TRANS/WP.30/2002/5 11 December 2001

CUSTOMS CONVENTION ON THE INTERNATIONAL TRANSPORT OF GOODS UNDER COVER OF TIR CARNETS (TIR CONVENTION 1975)

Draft proposal to amend Annex 6, Explanatory Note 2.2.1 (b)

Structure of load compartments (Door and other closing systems)

Note: See revised sketch attached.

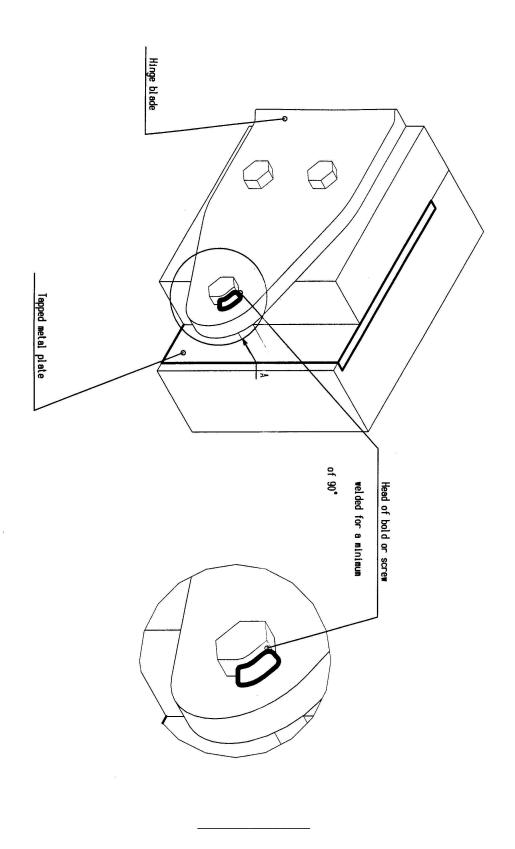
- 2. CLCCR wishes to propose an amendment to the final paragraph of Annex 2, Article 2, Explanatory Note 2.2.1 (b) (c) (i) in the following way:
 - "... the heads of the appropriate number of set bolts or set screws are so welded to the Customs sealing device, hinges etc., **that they are welded at the circumference for a minimum of 90 degrees** and that the set bolts or set screws cannot be removed without leaving visible signs of tampering, {see sketch No.1 appended to Annex 6}."

- 3. CLCCR is of the opinion that for set bolts or set screws inserted from the outside, whether they are completely deformed or the welding covers only 90 degrees of the circumference of the bolt or screw head, the level of Customs security of the vehicle would not be reduced. Indeed, CLCCR would contend that when a bolt or screw head is fully deformed it is easier to disguise a false head (one without a tail); for a false head, when welded for only 90 degrees, will "lift" at the unwelded edge. In either case, to avoid leaving visible signs of tampering would require extra welding of the device to re-fit the parts again after any manipulation.
- 4. Additionally, in cases of genuine reason for removal, for example accident damage, a bolt or set screw head welded for 90 degrees allows a quicker repair to be affected.
